## **83 Parkes Road, Collaroy Plateau**

### Geotechnical Comments for Section 4.55.

## **GEOTECHNICAL INVESTIGATION:**

### **New Houses at 83 Parkes Road, Collaroy Plateau**

## LOT 101 SECTIONS

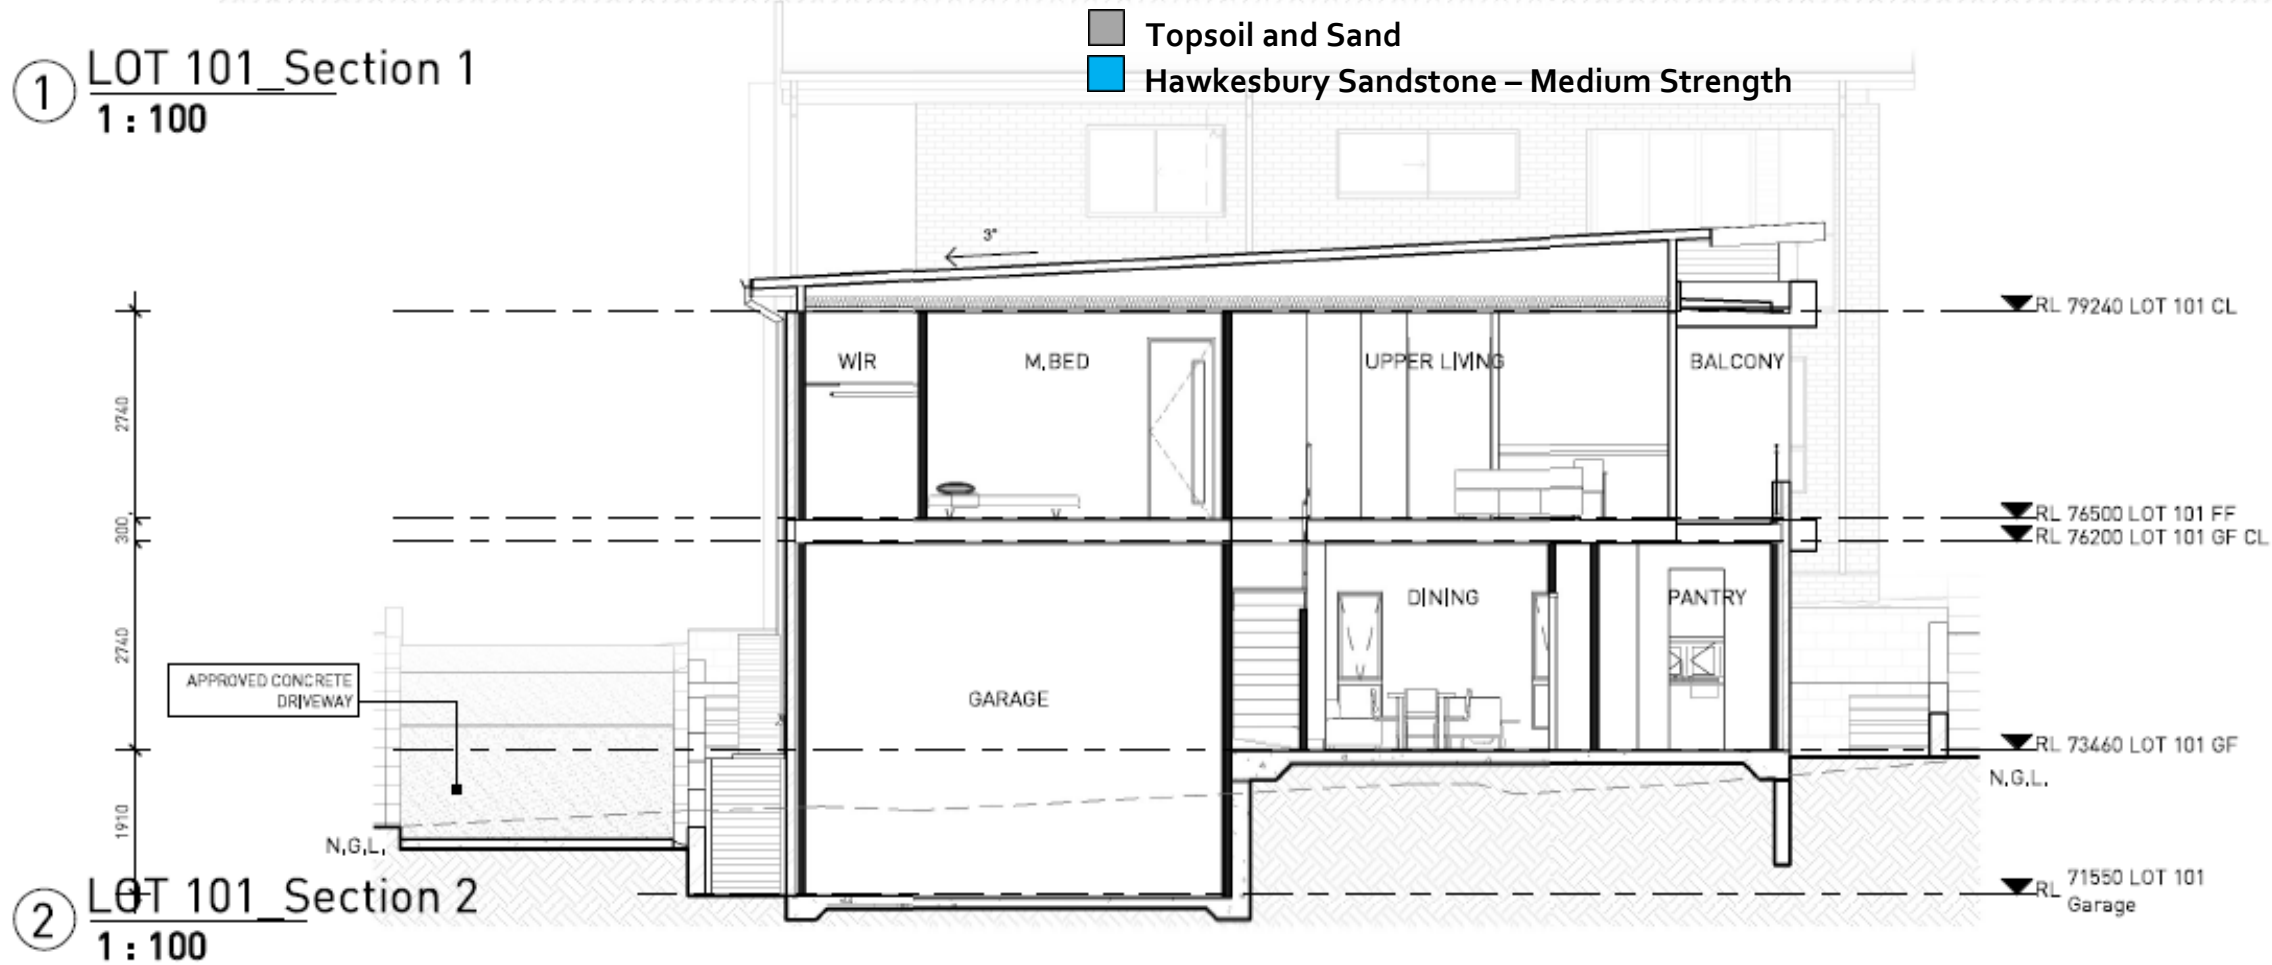
- Lower the level of the proposed garage on Lot 101 by 1.0m, increasing the maximum excavation depth from ~2.0m to ~3.0m. Add a media room above the lowered garage.

The increased excavation depth slightly increases the overall risk of the project. However, this does not alter the recommendations in the report carried out by this firm numbered J4462 and dated the 22<sup>nd</sup> August, 2022.
